From: Tracy Kulikowski <tkulikowski@westonct.gov> on behalf of Tracy Kulikowski
Sent: Thursday, August 06, 2020 11:14 AM
To: Sam Lampert
Cc: Dominic Esposito; jluiz@westonct.gov; jpjura@westonct.gov
Subject: Re: 100 Georgetown Road: C/O + CZC

100 Georgetown Rd.
Weston, CT

Re: Retaining wall

DRIVEWAY RETAINING WALL DETAIL

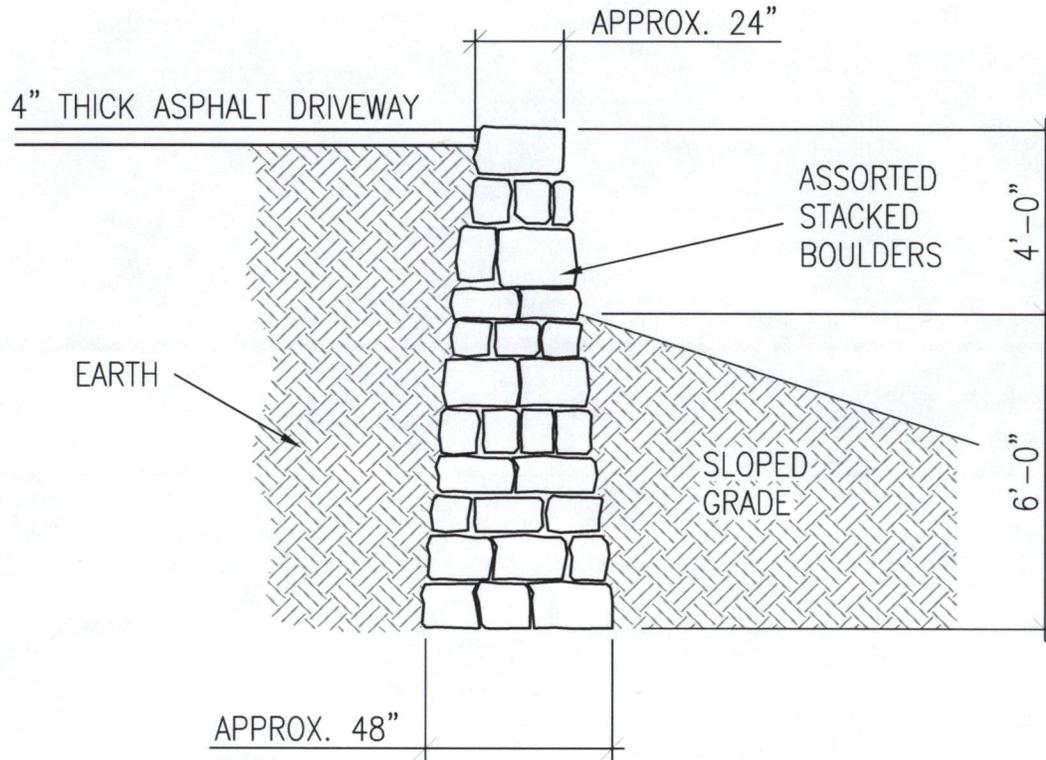
2. As-Built Survey. As we discussed in our meeting on January 9, and subsequently with Tom Quinn, regarding the construction of the retaining wall, the as-built survey needs to show the top of wall and bottom of wall spot elevations to demonstrate compliance with the Town's fence/wall regulations. My understanding is that your surveyor, Doug Faulds, has that information, however, it was not shown on the survey submitted to Jim on June 11. That survey should be resubmitted to Jim with the spot elevations.

- 3a. Once all of the required site work is complete, David Pattee can conduct his inspection to close out the Conservation Commission's permit.
4. Safety Railing. The approved site plan by Peak Engineers contains a safety railing detail for the driveway along the retaining wall. If it has not already been installed, the safety railing as Dominic requested and we discussed on January 9, should be installed.
